Subject: AP1000 COL Response to Request for Additional Information (TR 36)

Response to Request for Additional Information on Technical Report No. 36

RAI Response Number: RAI-TR36-012

Figure 2-7  
Turbine Trip  
(Minimum DNBR Case)

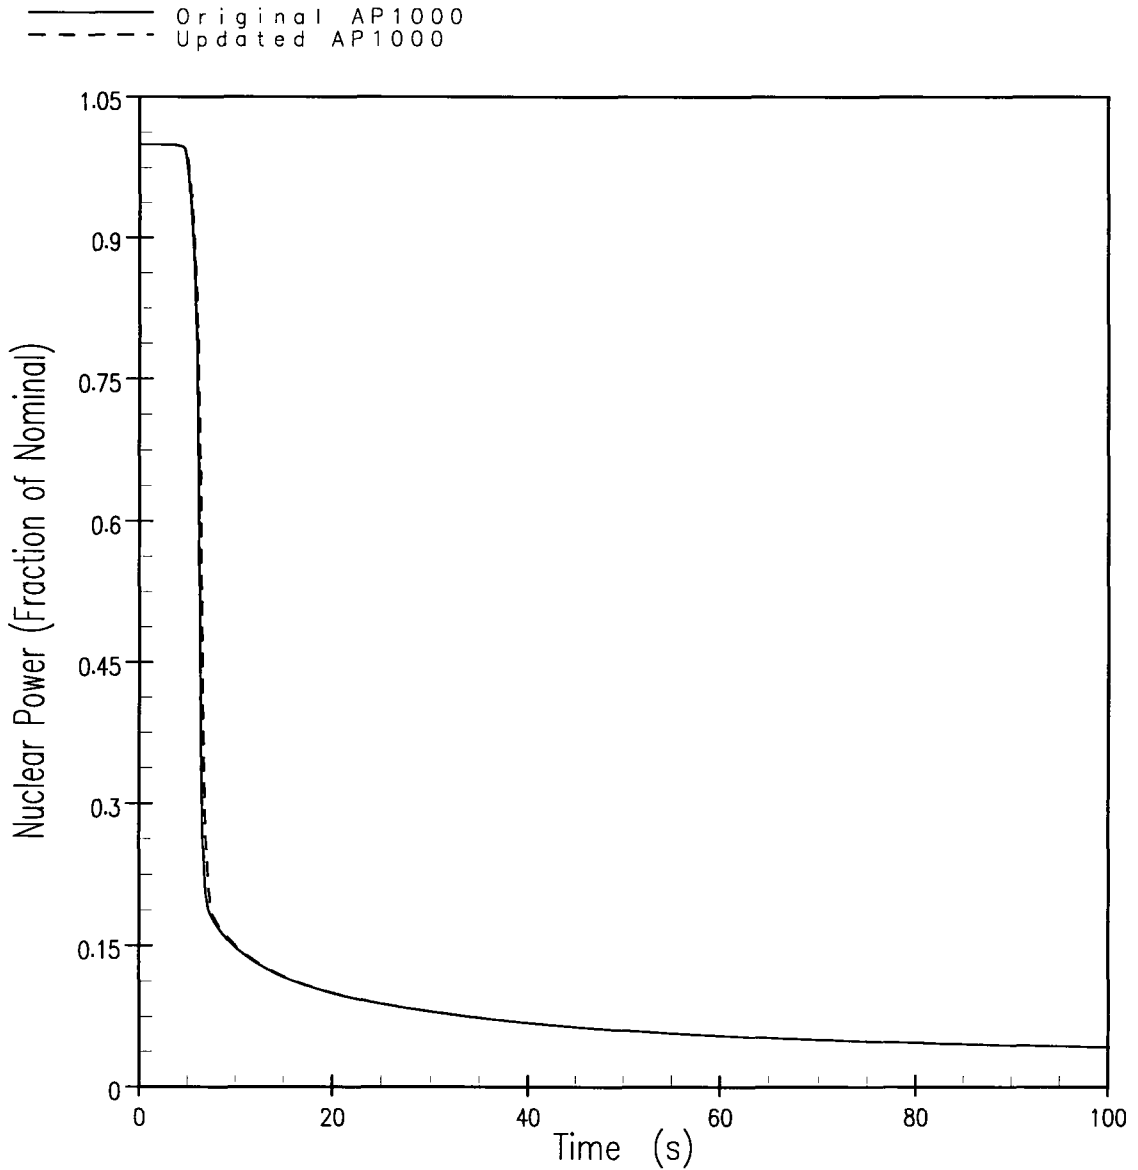
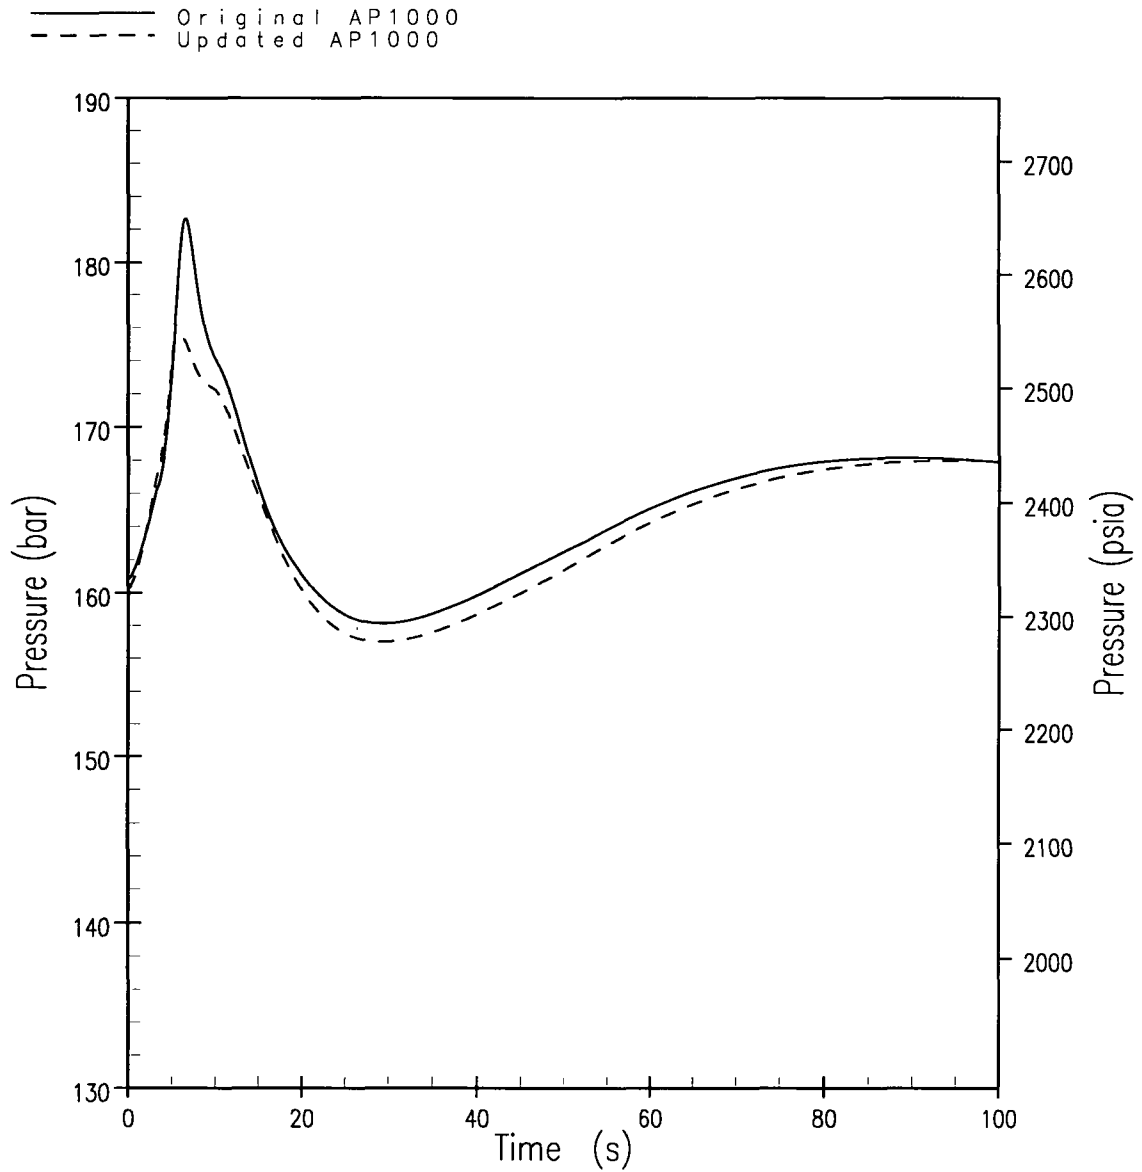
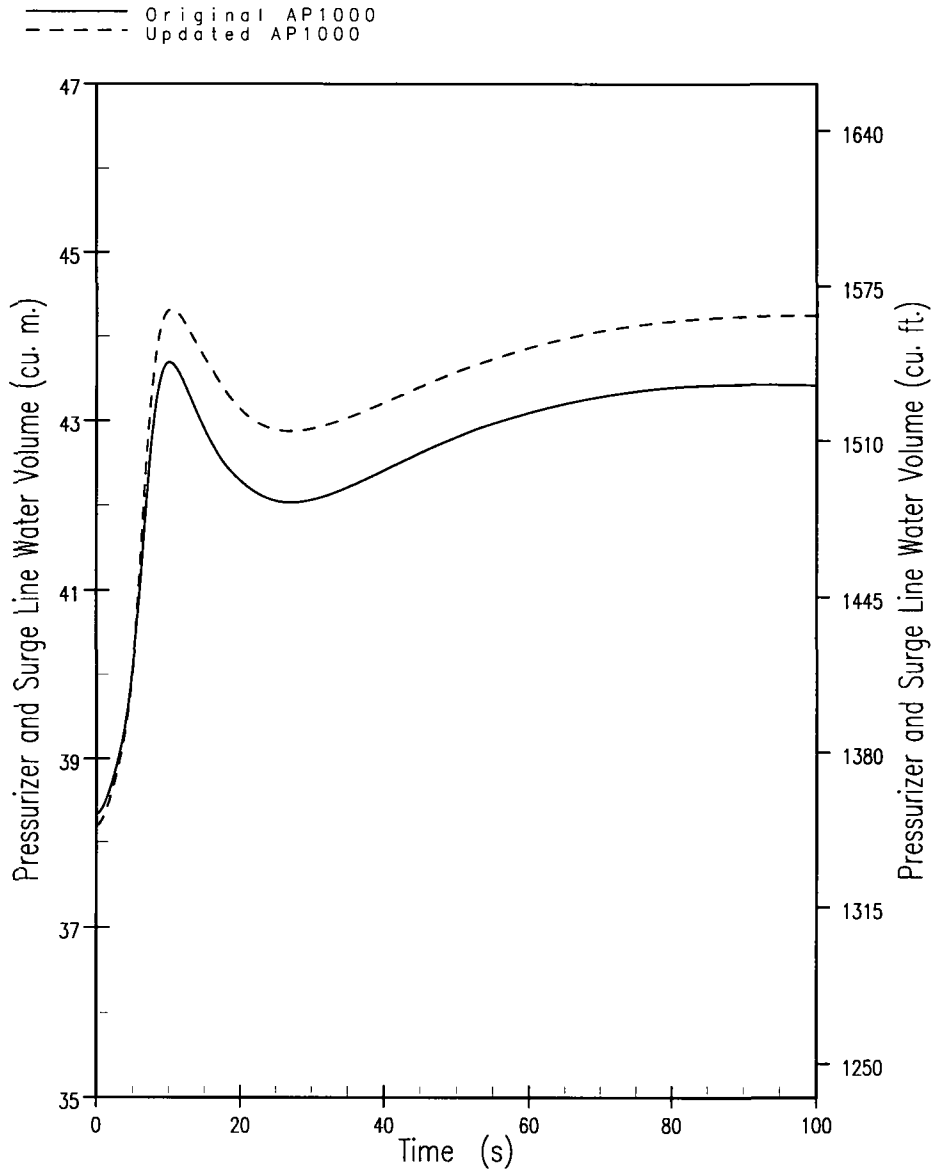
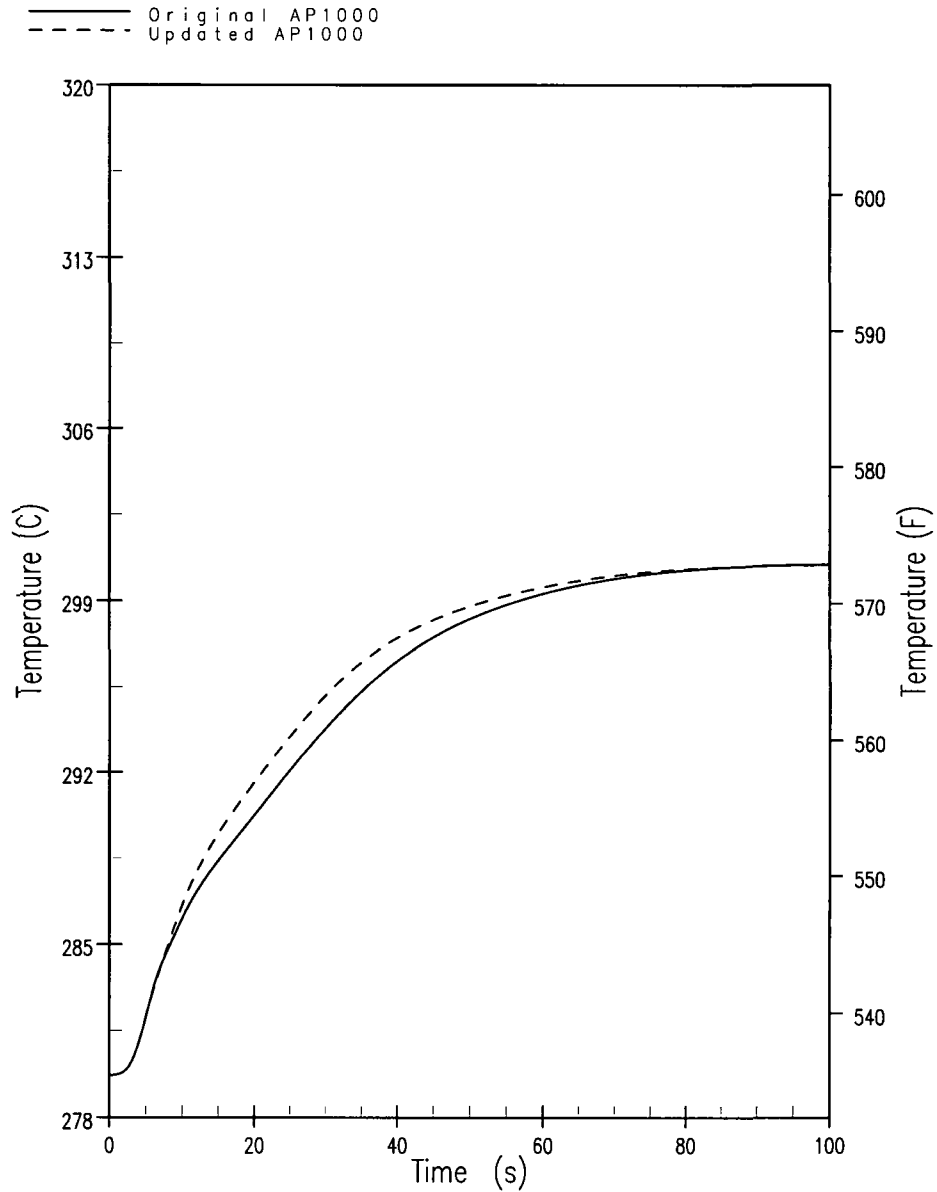
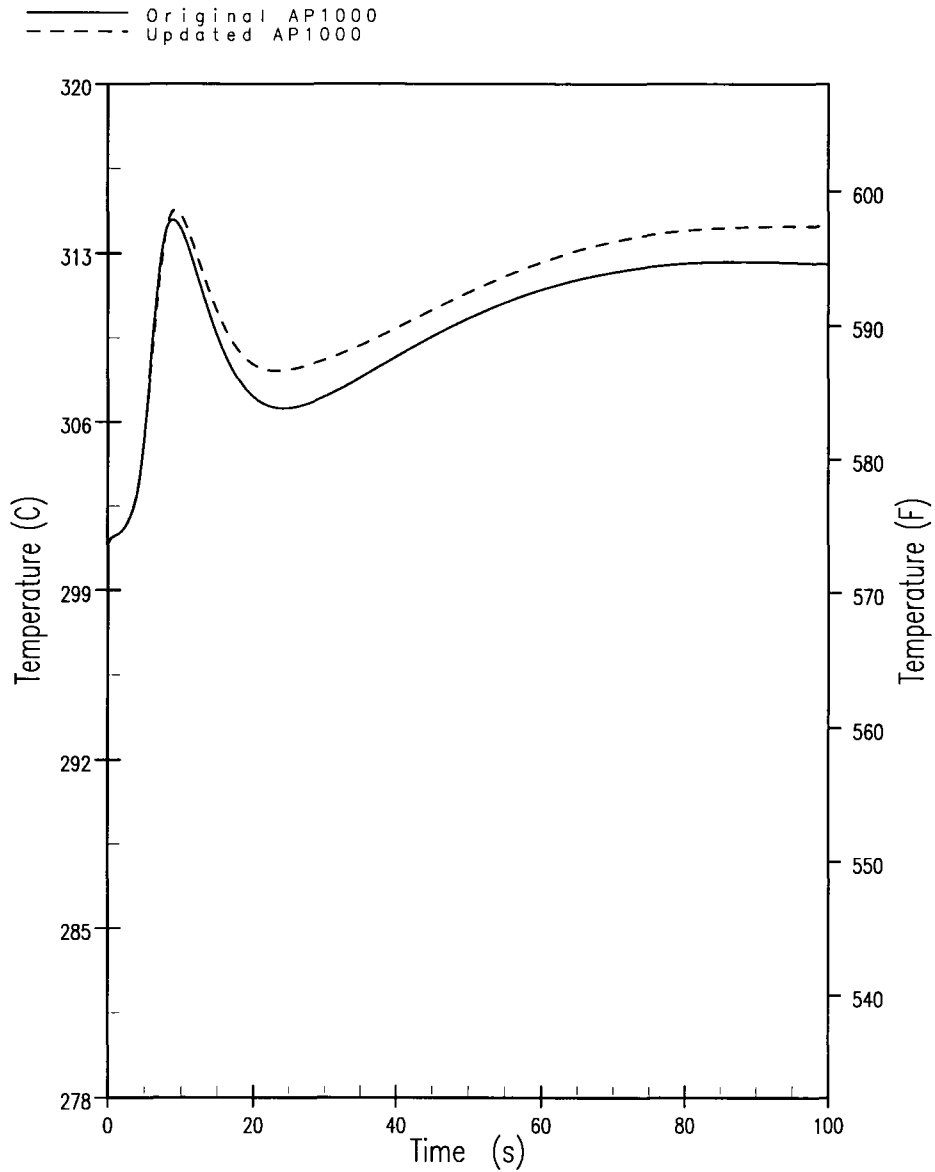
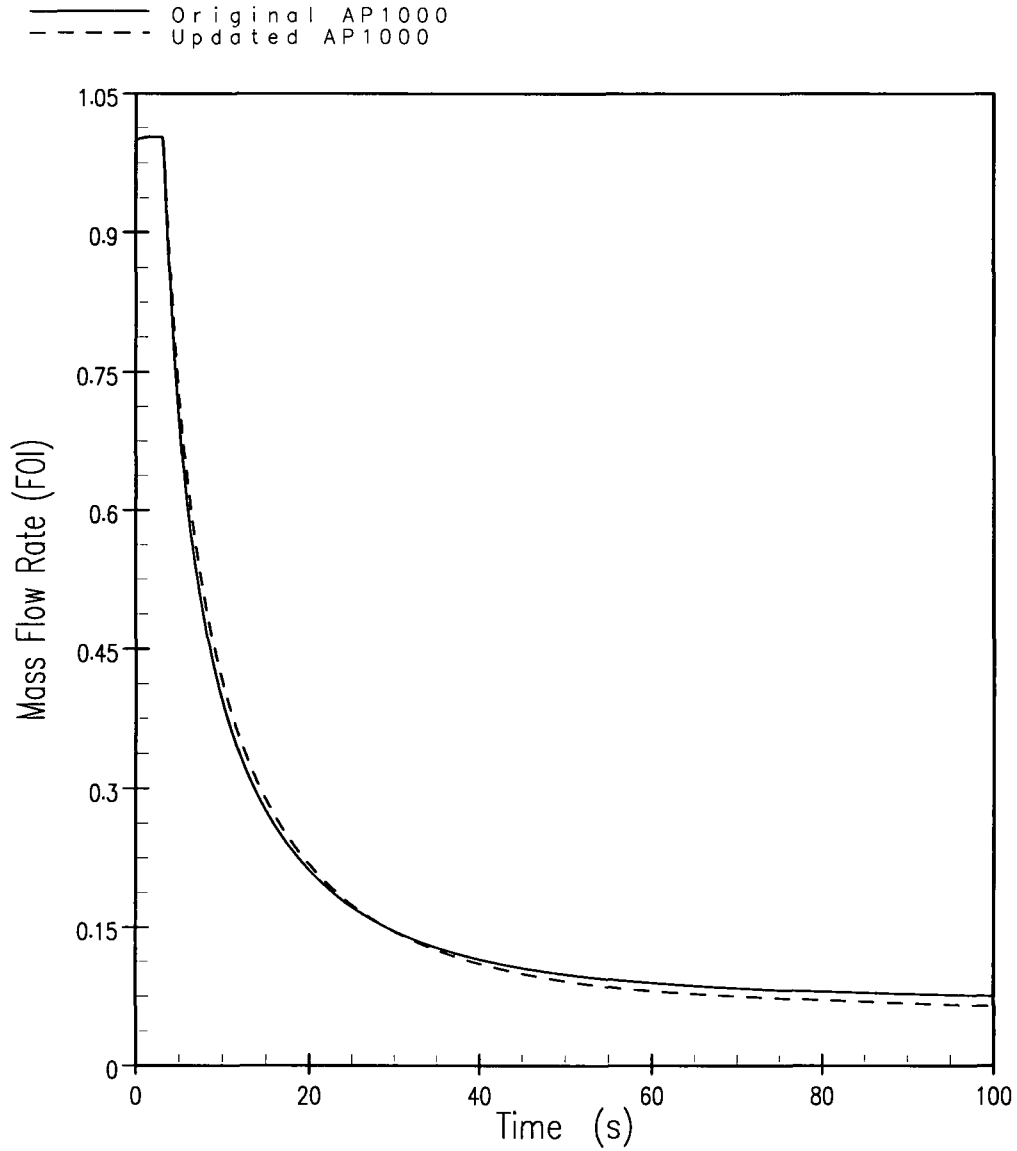
The pressurizer changes affect many parameters such as the cross-sectional area of the pressurizer, pressurizer vessel height, initial pressurizer water level, pressurizer setpoints, ADS stages 1, 2, and 3 elevation and pressurizer heater length. We are concerned about the combined effects of the values changed for the above parameters on the thermal hydraulic response during transient and accident conditions. We determined that the qualitative statement in the RAI response is not sufficient to resolve the RAI issue. We request Westinghouse perform the quantitative analyses for the limiting event for each of the following Standard Review Plan chapter 15 event categories:

The most limiting case with respect to minimizing the core DNB ratio is the case with the pressurizer pressure control system available, with minimum reactivity feedback and without offsite power available. Results for the limiting DNB ratio case are shown in Figures 2-7 through 2-12. A sequence of events is provided in Table 2-1 and is identified as Case A.2. The minimum DNB ratio for the updated AP1000 is 1.589 as compared to a value of 1.57 for the original AP1000 plant configuration. The existing turbine trip analysis is bounding for the updated AP1000 configuration.
